Objection to Planning Proposal of 20 Flaxman Terrace Application No. 2016/0788/P

Camden Council Customer feedback and enquiries
Comments on a current Planning Application - Ref. 20518725

Attached photographs of 20 Flaxman Terrace taken from our rooms in Flat 7 (sending through email if I may)

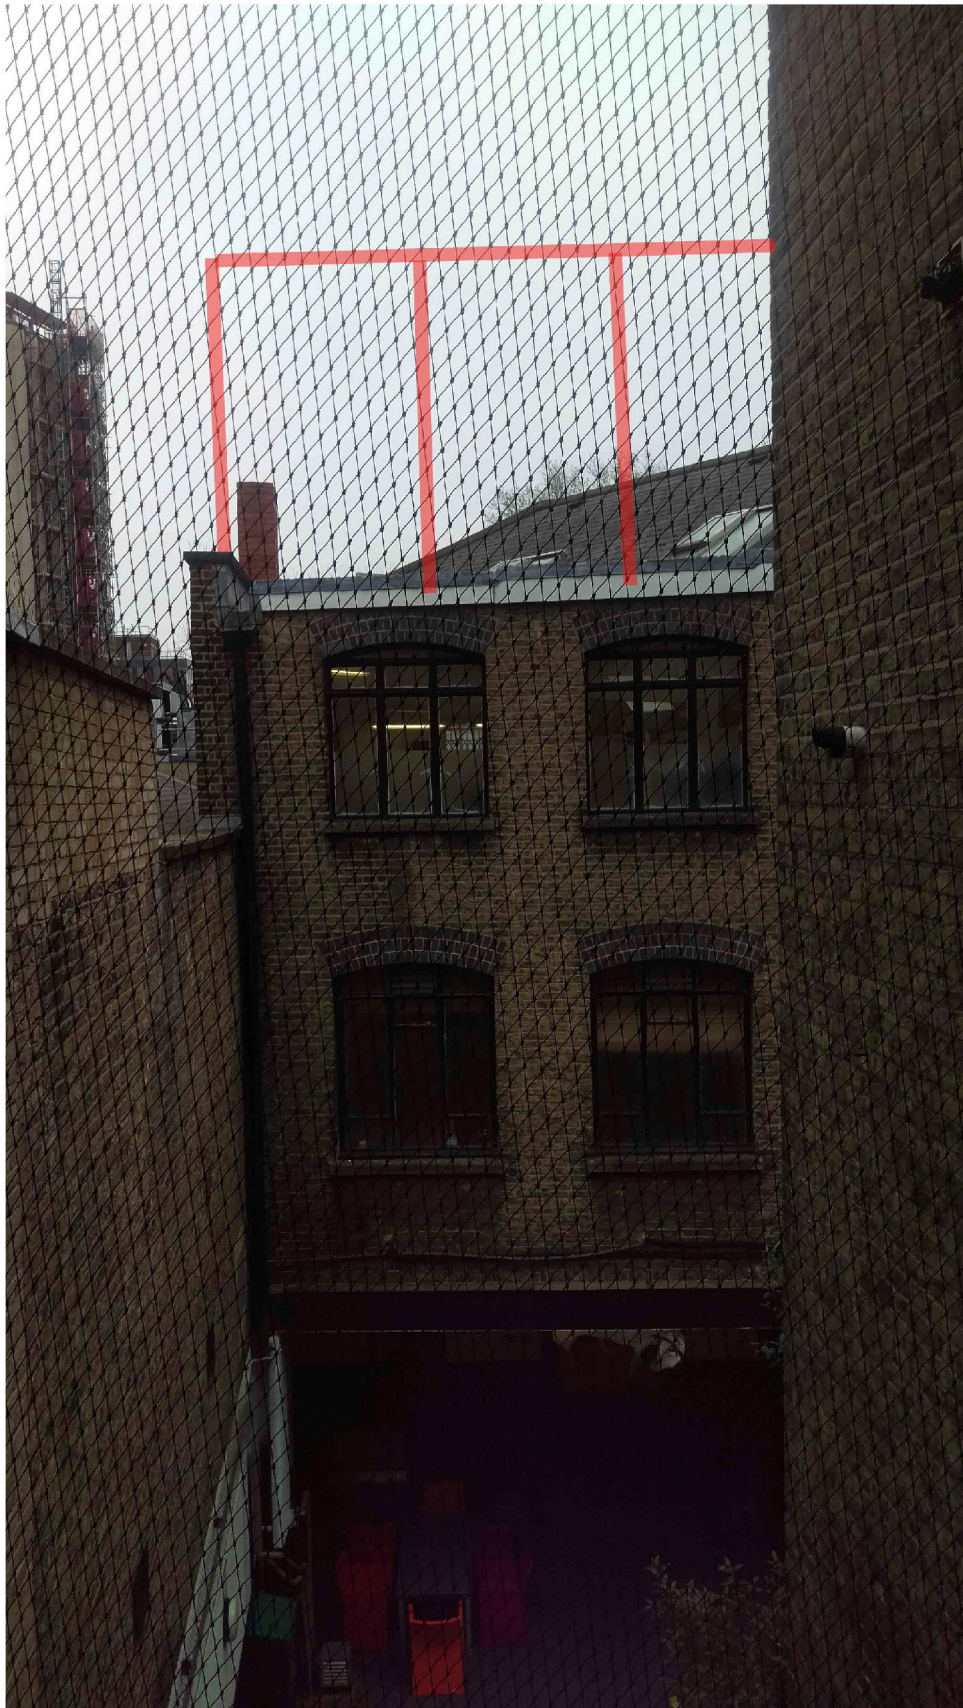
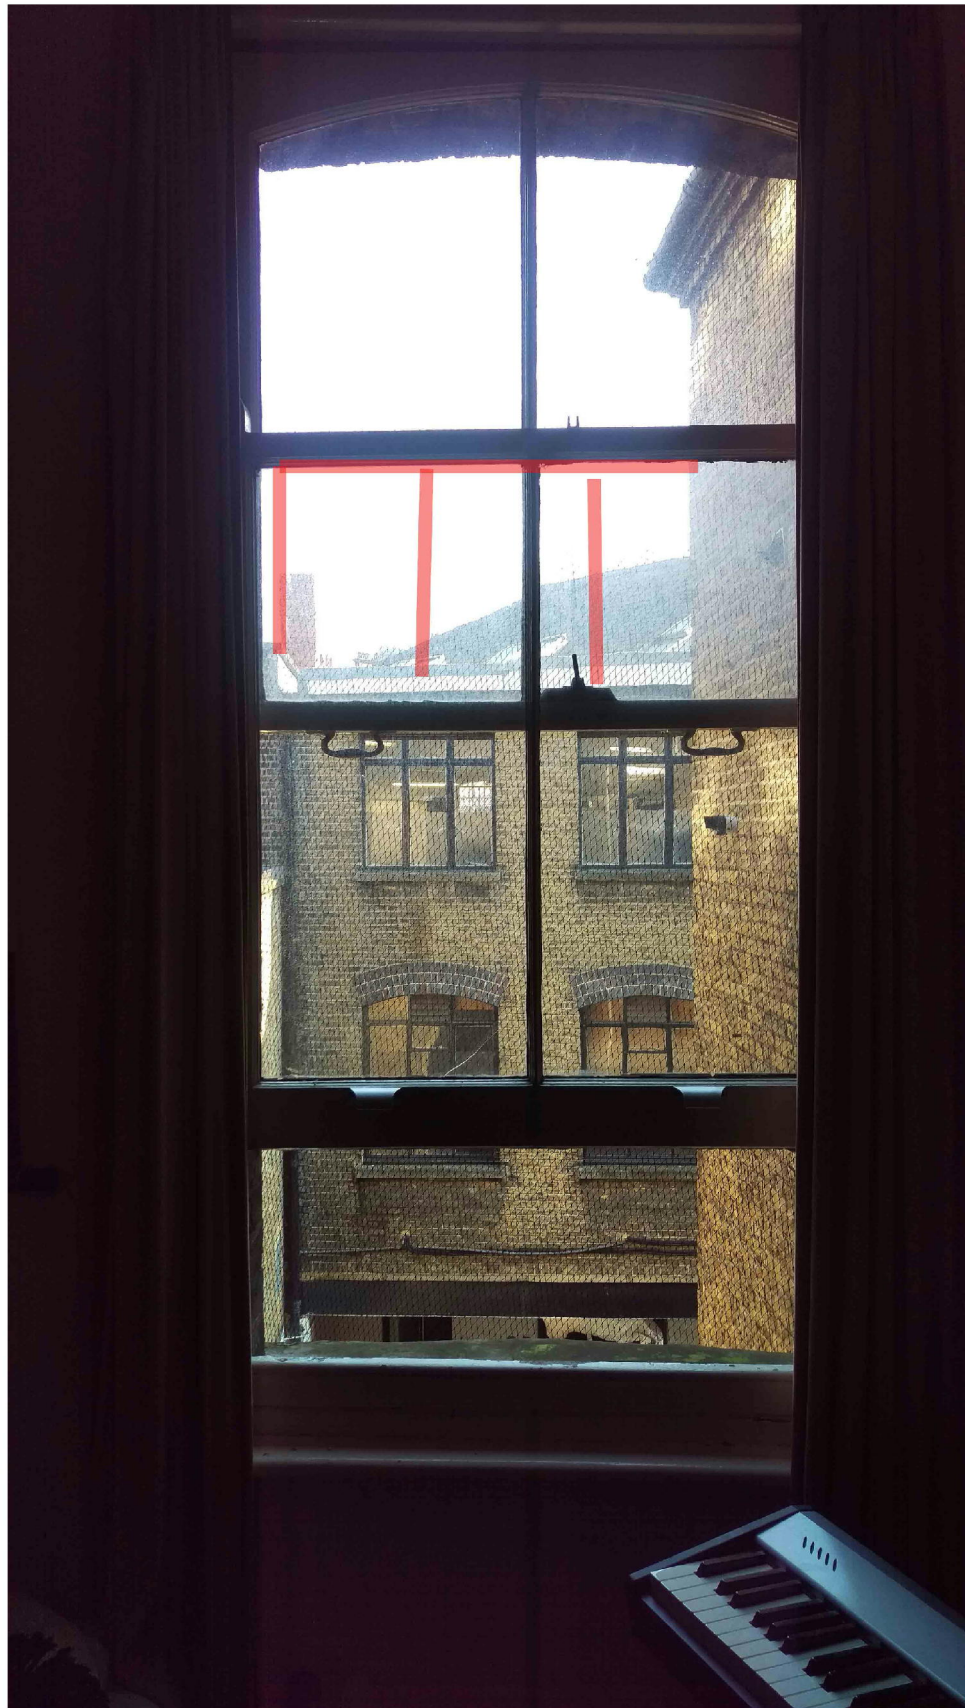
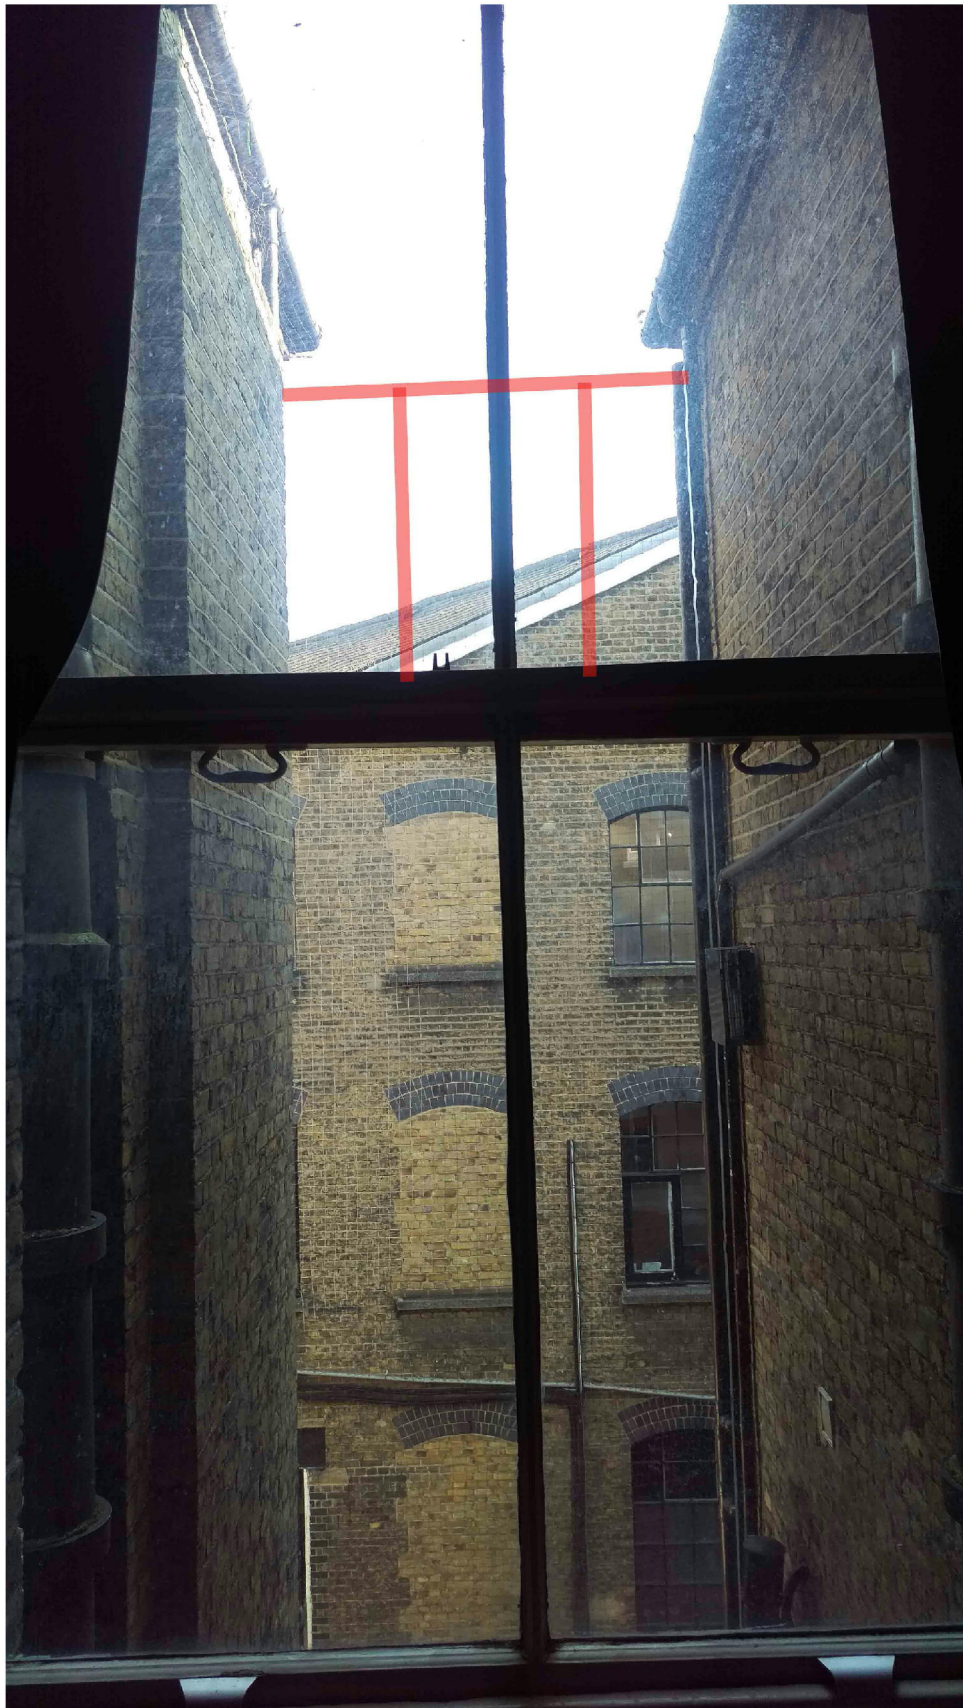
My own flat is no.7 on the second floor. And directly facing this new proposed addition we have two bedrooms and one dinning/kitchen room. I am attaching photos taken from the east facing windows of these 3 rooms, which will demonstrate the critical privacy/day light problems we could suffer.

The photos show that the immediate effect of adding one to two new 'transparent' office floors (shown as red lines) on top of the existing building facing these rooms is quite substantial.
